Amendment Notice 1

Licence Number L5110/1988/10

Premises Lawlers Gold Mine

Amendment

Map of storage locations

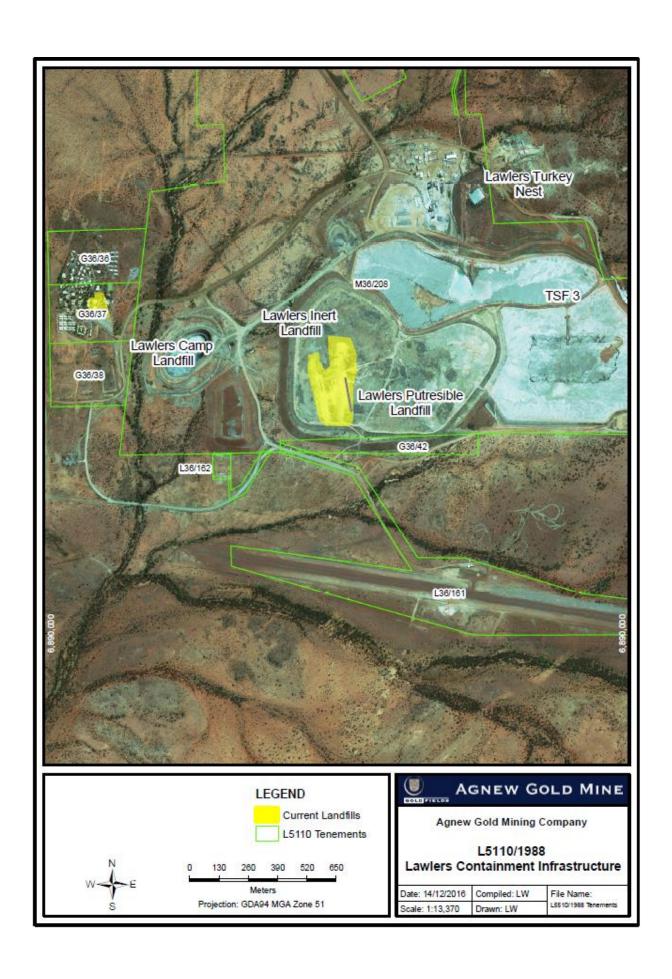
2. Schedule 1 of the licence is amended by the replacing the map of storage locations and amending the text above the map by the deletion of the text shown in strikethrough and the insertion of red text shown in underline below::

The locations of containment infrastructure detailed in Table 1.2.1 and Table 1.2.2 are shown in the maps below.
